This Errata Sheet refers to:

AT91RM9200 devices packaged in 208-lead PQFP or 256-lead BGA with the marking AT91RM9200-CI or AT91RM9200-QI and with the product number 58A07F marked in the bottom left-hand corner of the package.

### AT91RM9200

## Errata Sheet

**Figure 196.** Typical Connection to a RS485 bus.

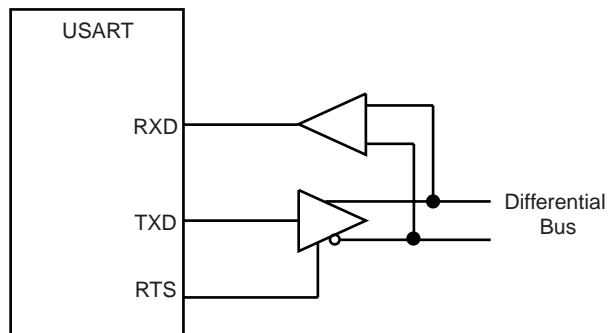
1. "The RTS pin is driven **low** when the trasnmitter is operating."  
**Should read:**  
"The RTS pin is driven **high** when the transmitter is operating."
2. "Significantly, the RTS pin remains **low** when timeguard is programmed..."  
**Should read:**  
"Significantly, the RTS pin remains **high** when timeguard is programmed..."
3. Figure 196 and Figure 197 give incorrect descriptions of RTS behavior. The correct descriptions of RTS behavior are as follows:

The correct sentences and correct figures are to be implemented in the next update of the datasheet, Lit° Number 1768C.
